**Fermi National Accelerator Laboratory
Batavia, IL 60510**

**LARGE HADRON COLLIDER
YOKE & SKINNING ASSEMBLY TRAVELER**

**Reference Drawing(s):
Skinned Yoke Assembly
5520-ME-369579
Final Long Cold Mass Assembly
5520-ME-369578**

Traveler or Document Title LHC Yoke & Skinning Traveler

TRR# 1255 (3.1)

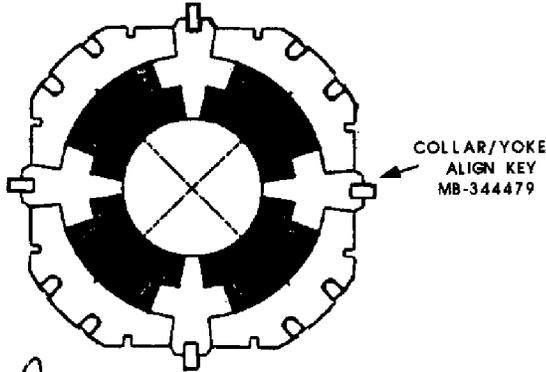
- 3.1 Modified Step. Added "Modify the Lengths of the Keys to fit."
- 7.20 Added Step. "Inspect the Welds and determine if a 6th pass is necessary." DR No. HGQ-0263.
- 9.1 Added Step. "Install the Jumper Wires (length as required) (MA-369833) on the Heater Strips at the NON-Lead End as per Figure 1." (Old Step 3.1 of 333498)
- 9.2 Added Step. "Install Saddle Shim Stock (MA-369817) Outer pieces (Qty. 4) into the four quadrants. Modify as necessary to fit properly."

- 4.6 Insert the Lower Yoke Packs into the Bottom Skin in accordance with the Skinned Yoke Assembly (ME-369579).

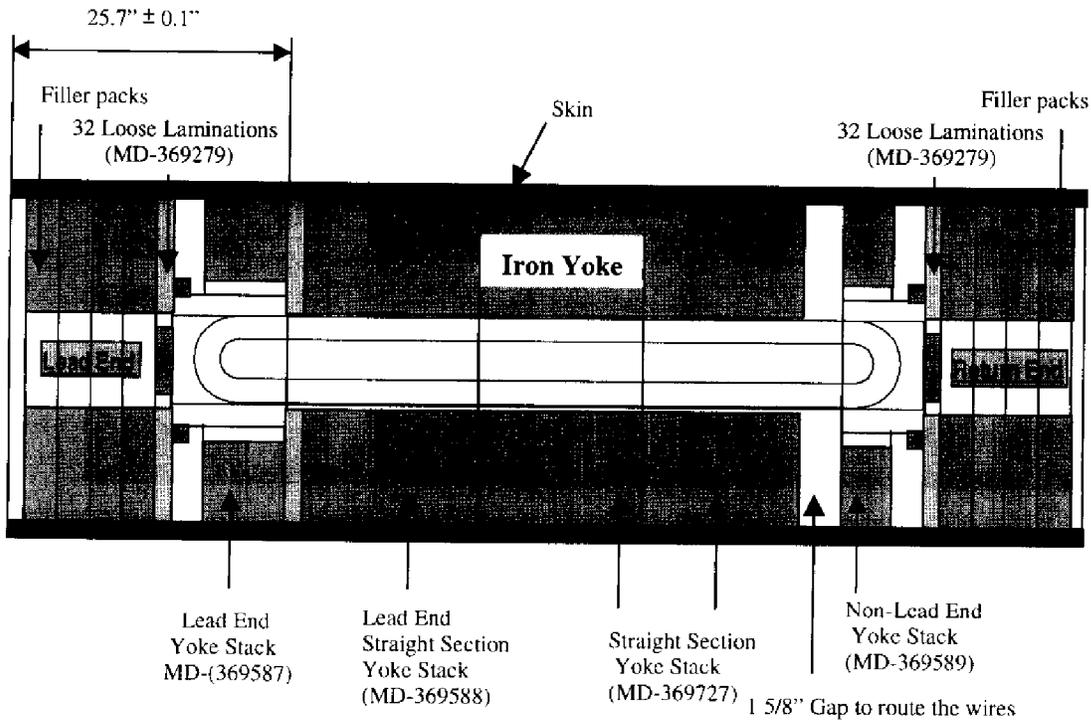
- 4.4 Modified Step. Added "Straight Section Yoke Pack - Non - Lead End MD-369828" to the Table. DR. No. HGQ-0262.
- 4.6 Modified Step. Changed to "Using the Iron Core Transport Fixture Assembly (ME-344634), insert the five Lower Yoke Packs into the Bottom Skin in accordance with the Skinned Yoke Assembly (ME-369579). Ensure all yoke packs are in contact, excluding the 1/4" gap. 1) Lead End Yoke Stack (MD-369587) 2) Lead End Straight Section Yoke Stack (MD-369588) 3) Straight Section Yoke Stack (MD-369727) 4) Straight Section Yoke Stack - Non-Lead End (MD-369828) 5) Non-Lead End Yoke Stack (MD-369589)." Changed Drawing to Show New Straight Section Yoke Pack (MD-369828), 9 Stainless Steel Laminations at the Lead End and 21 Stainless Steel Laminations at the Return End. DR. No. HGQ-0262.

5.3 Install the Top Yoke Lamination Packs as per the Skinned Yoke Assembly (ME-369579).

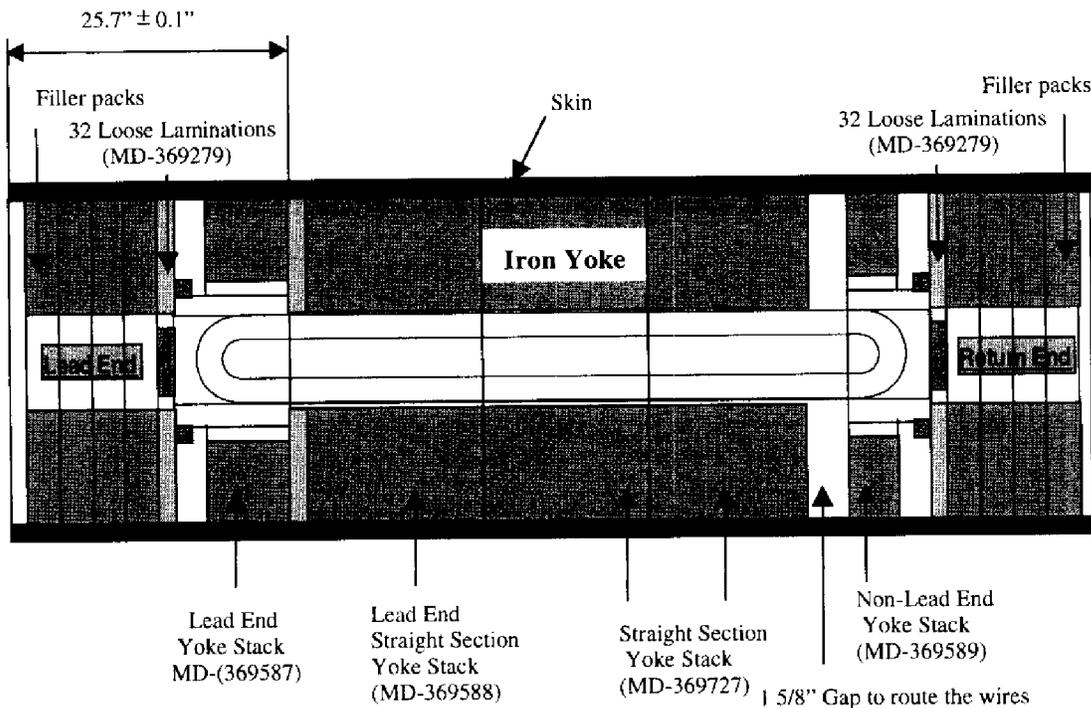
- 5.3 Modified Step. Changed Drawing to Show New Straight Section Yoke Pack (MD-369828), 9 Stainless Steel Laminations at the Lead End and 21 Stainless Steel Laminations at the Return End. DR. No. HGQ-0262. Changed Note from "...Top Lead End ..." to "...Upper Lead End..."
